ADDENDUM NO. B

PROJECT NAME: Outdoor Adventure Center
UNL PROJECT NUMBER: C220P001
RFP# 909495-12
CONSULTANT: RDG Planning & Design
ADDRESS: 900 Farnam on the Mall, Suite 100, Omaha, NE 68102
DATE OF ISSUANCE: November 12, 2012
DATE OF BID OPENING: November 15, 2012

ROOF FRAMING - BIKING AND ADMIN
1/8" = 1'-0"

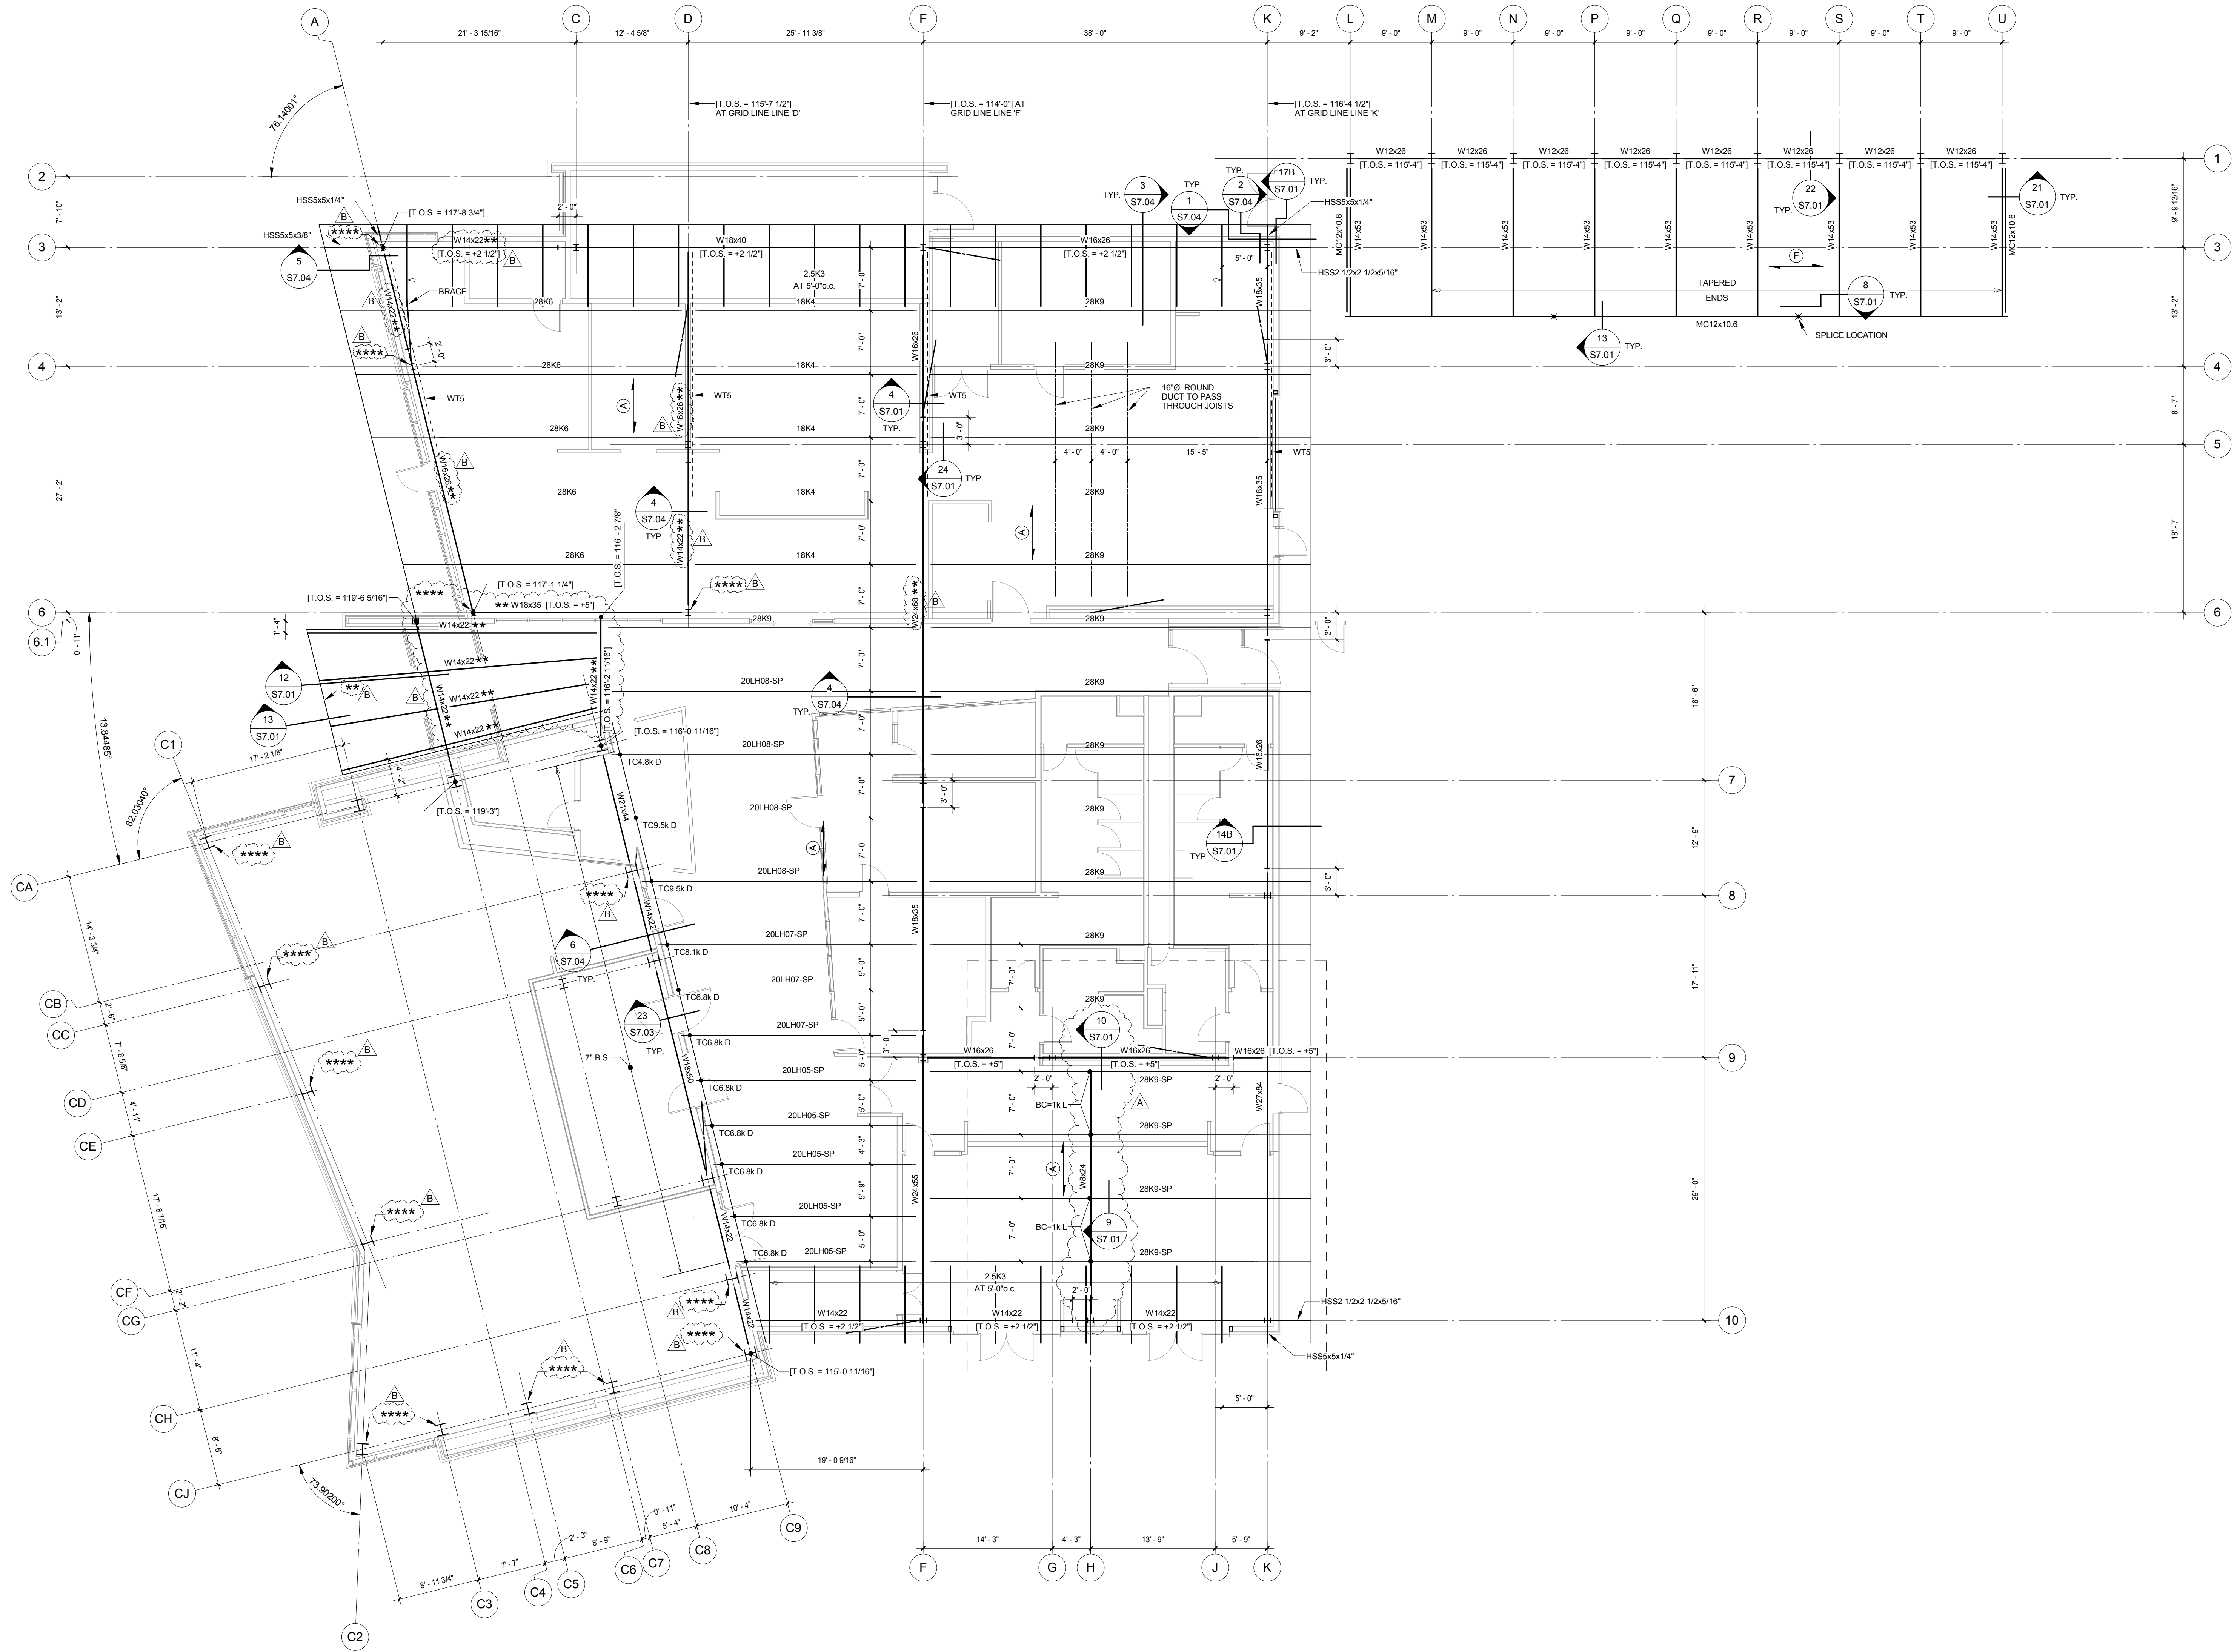
BSD-1 Replace Sheet S1.03 with attached Sheet S1.03 showing clouded locations of AESS steel.

ROOF FRAMING - CLIMBING

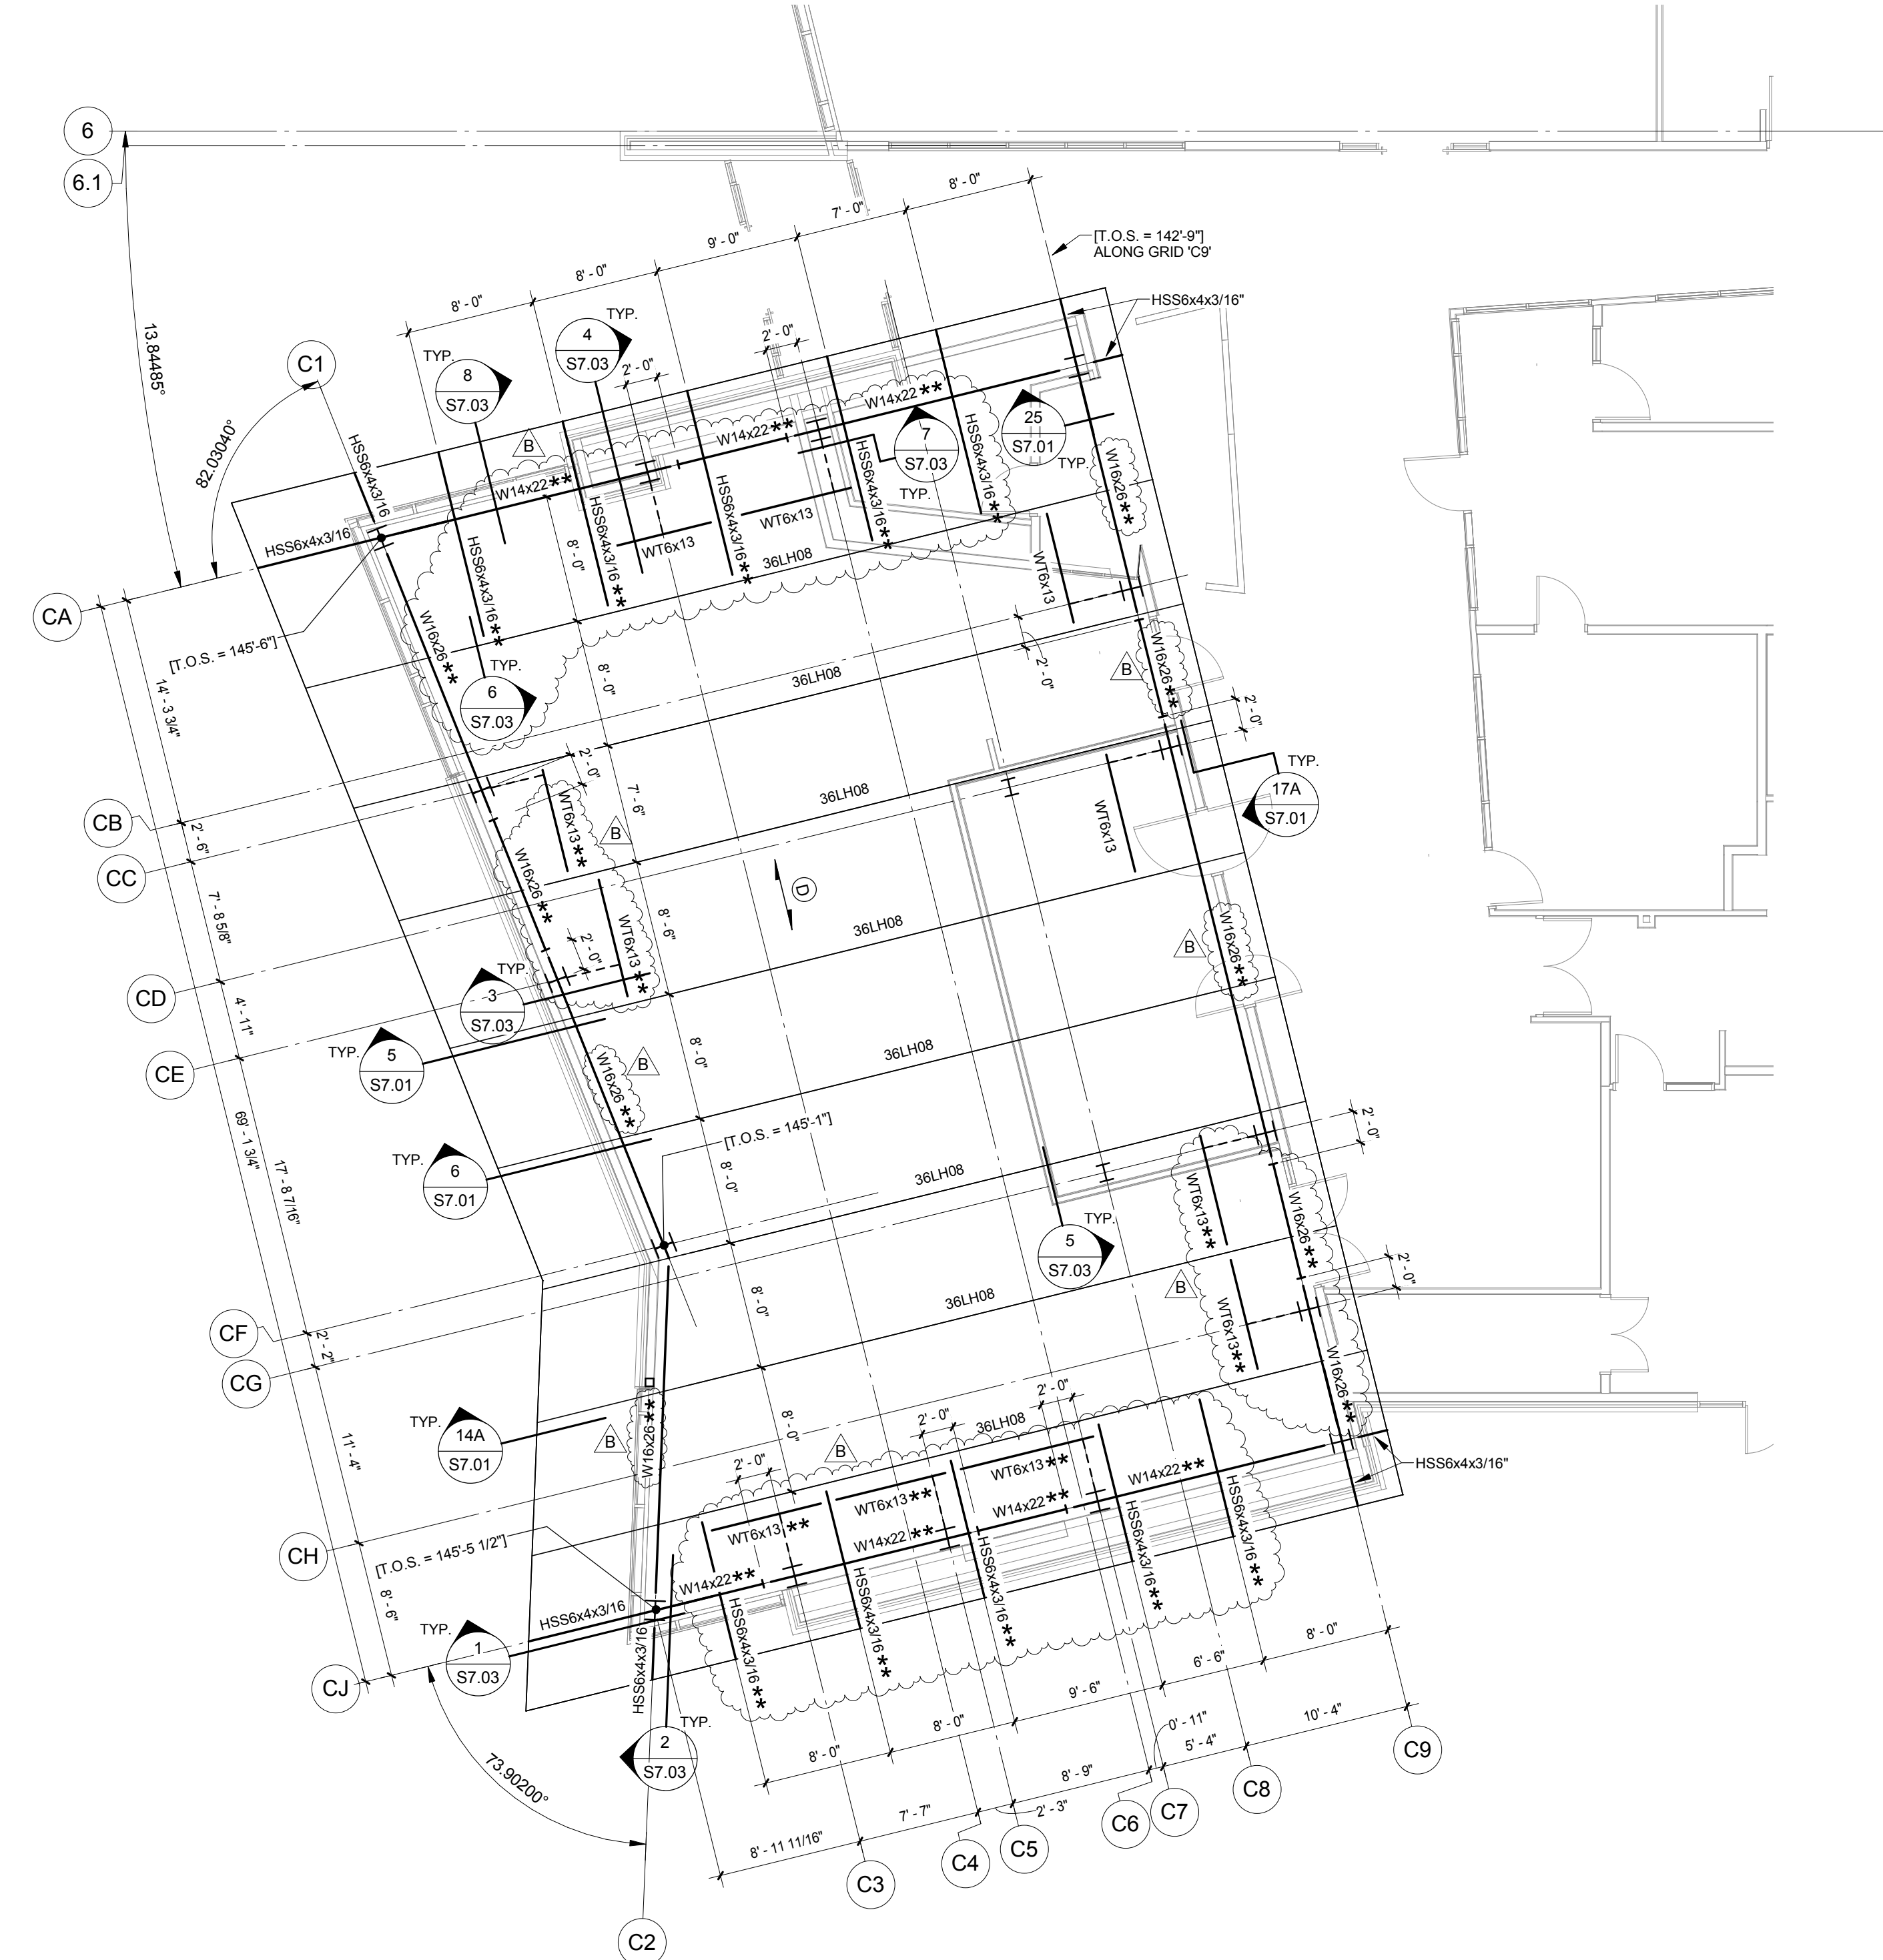
BSD-2 Replace Sheet S1.04 with attached Sheet S1.04 showing clouded locations of AESS steel.
